#	COMMENT PROVIDER	COMMENT	RESPONSE
1	Jerome Maa, Virginia Institute of Marine Science (October 20, 2007)	<p><i>Question 1: In your assessment, do the modeling results adequately estimate the relatively contribution from vehicle brake pad wear debris to copper levels in the San Francisco Bay? What improvements, if any, do you recommend for the presentation of results?</i></p> <p>It appears to me that the total amount of copper generated from the brake pad wear debris can be estimated from the total number of cars and trucks registered in local governments that are associated with each watershed and the average wearing rate. Of course, some of the debris may never come to the San Francisco Bay, but in general, the majority of the debris will come to the bay sooner or later. With this information, the relatively contribution from brake pad wear debris can be further confirmed. For example, if URS found that 90% of the debris generated comes to the bay, then the relative contribution would be more convincing. This information should be relatively easy to obtain and very useful.</p>	Comment noted. The work described by the commentor is a watershed modeling issue and not within URS's sc

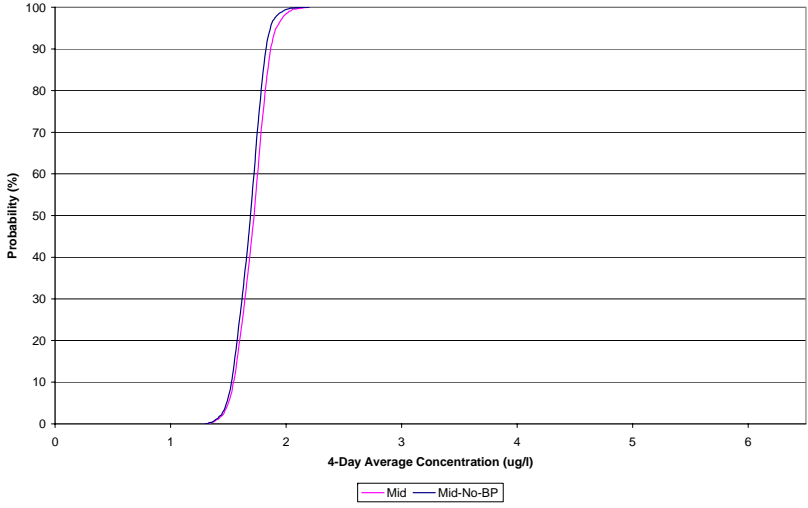
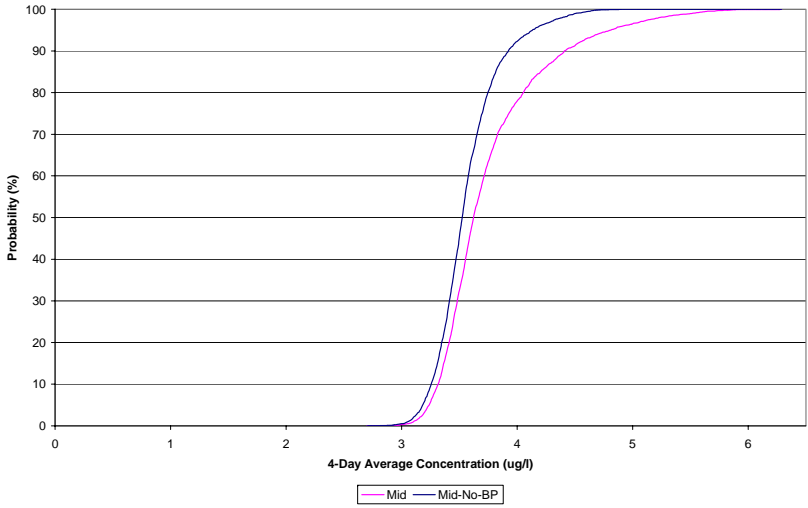
4	Kelly Moran, TDC Environmental (November 9, 2007)	<u>Mass balance.</u> The mass balance for the lower South Bay (Section 3.2.3) estimates that 99.96 percent of the total copper in the system is in the sediments. What are the implications of this relative to the brake pad copper modeling results?	We will include a discussion of the implications in the final draft of the report.
5	Kelly Moran, TDC Environmental (November 9, 2007)	<u>Modeled benthic copper concentrations.</u> The 10- and 20-year data for lower South Bay in Table 6 and the accompanying discussion in Section 3.2.2 do not appear to match the results in Figure 19. The table shows lower South Bay concentrations decreasing from the initial model concentration, while the figures appear to show increases.	The South Bay results shown in the table and plots conflict because the table represents area-averaged results (many grid cells), while the plots represents results from one grid cell. In the South Bay, some grid cells increase in benthic copper, while others decrease. It appears that benthic copper tends to increase at channel sites and decrease at mudflat sites. We will add a Coyote Creek mudflat site as another site of interest and present the dissolved and benthic copper results for this site to show that benthic copper is increasing and decreasing in this area. Also, instead of relying on the results of just one grid cell, more area-averaged results will be shown for various subsections of the Bay to provide a more holistic picture. See response to comment #12 from Kelly Moran.
